LIC-12-0006
February 10, 2012

**SUBJECT: Fort Calhoun Station (FCS) License Amendment Request (LAR) 12-01,
Proposed Change to Establish the Reactor Protective System (RPS)
Actuation Circuits Limiting Condition for Operation (LCO)**

OPPD's Evaluation of the Proposed Change(s)

REACTOR PROTECTIVE BLOCK DIAGRAM

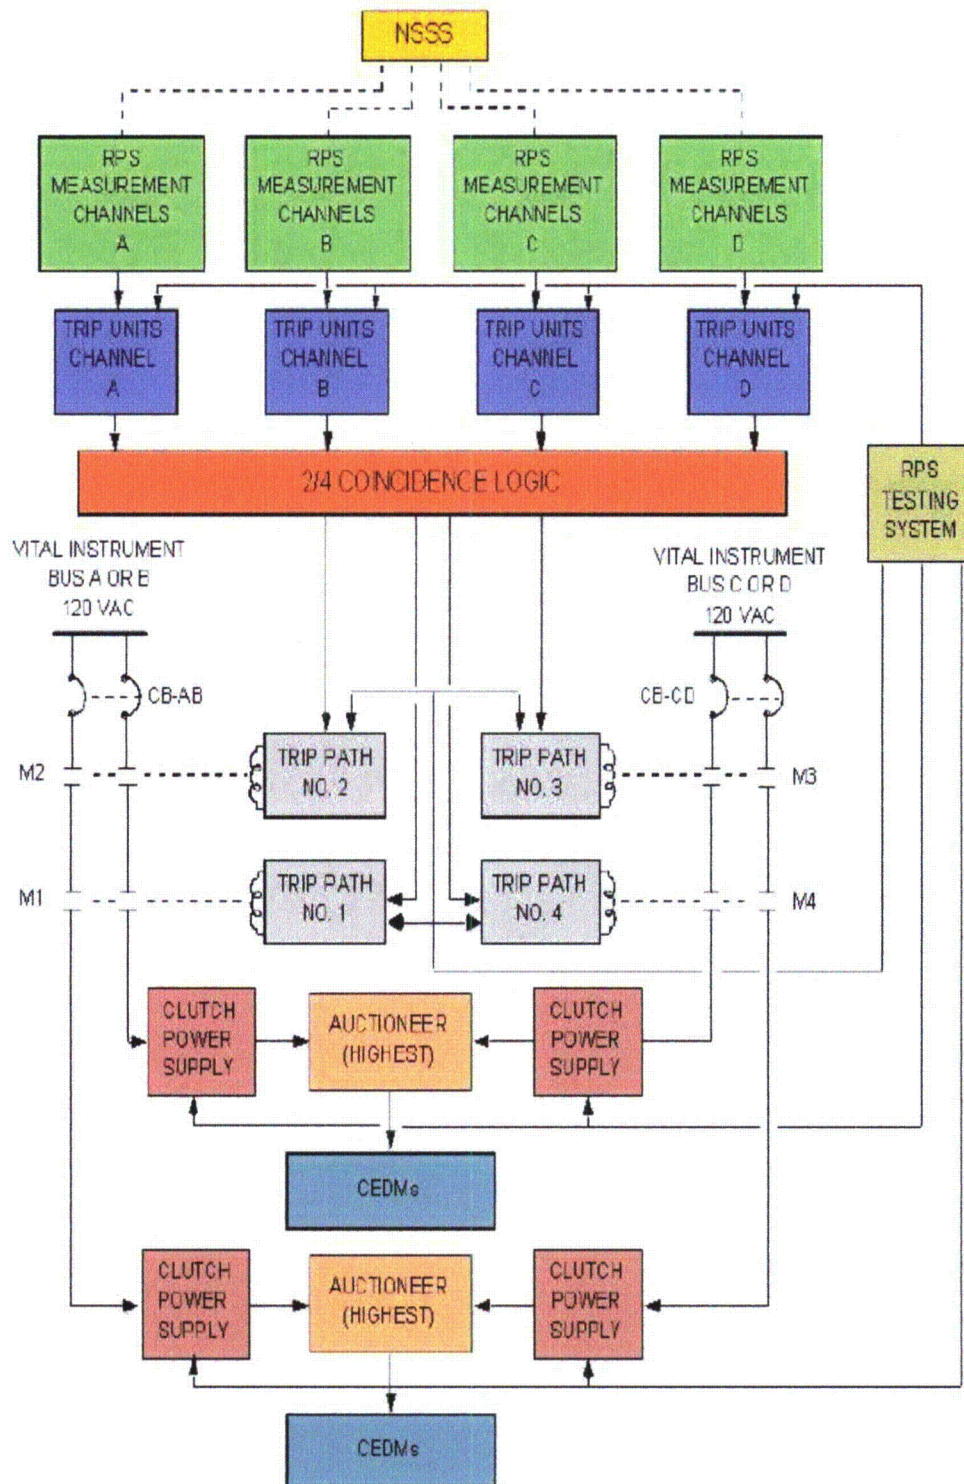
A block diagram of the RPS is provided below:

Currently, the TS contain surveillance requirements in TS 3.1, Table 3-1, Item 12, for a quarterly functional test of the RPS logic units, and TS 3.1 Table 3-1, Item 10 for a prior to critical functional test of manual trips, but contains no LCO for the RPS logic units. Since there is no LCO, if an RPS logic unit or trip initiation channel becomes inoperable, TS 2.0.1 would apply. TS 2.0.1 specifies corrective measures to be employed for system conditions not covered by LCOs. The corrective measures include placing the unit in Hot Shutdown within 6 hours, in at least subcritical and less than 300 degrees F within an additional 6 hours and placing the unit in Cold Shutdown within the following 30 hours. In certain situations these actions are non-conservative compared to NUREG 1432, (Reference 6.4). As an example, NUREG 1432 requires the reactor trip breakers be opened immediately for certain conditions.
